Alternative assessment of ALKS performance

Response to OICA's comments

OICA's comments (UNR157-04-10) to EC proposed text (UNR157-03-06)

OICA's comments (UNR157-04-10) to EC proposed text (UNR157-03-06)

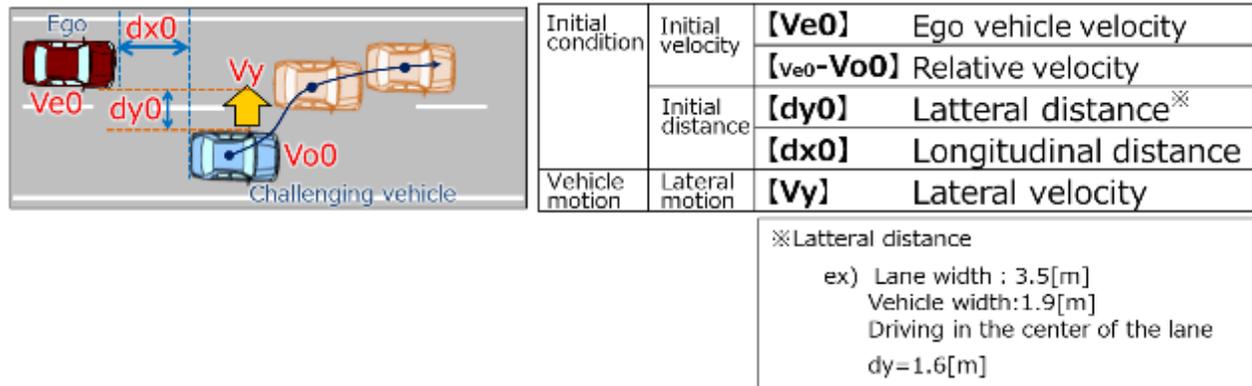
Industry considers the proposed concept **not mature enough to replace the recently introduced provisions** for ALKS. The discussion should **first be finalized within FRAV/VMAD**, then a **comparison between the new approach and what is established for ALKS** shall be made and if necessary the new approach can be **used to provide guidance within ALKS** on how to assess the performance of the system.

1. Since the model in the amendment proposal has the same scope as that used in the current R157 (define the performance of an **attentive and competent human driver**) we don't believe that the discussion should be necessarily finalized in FRAV
2. A thorough **assessment of the model has been performed** including **comparison** with the performance models used in R157 and other models (i.e. RSS).
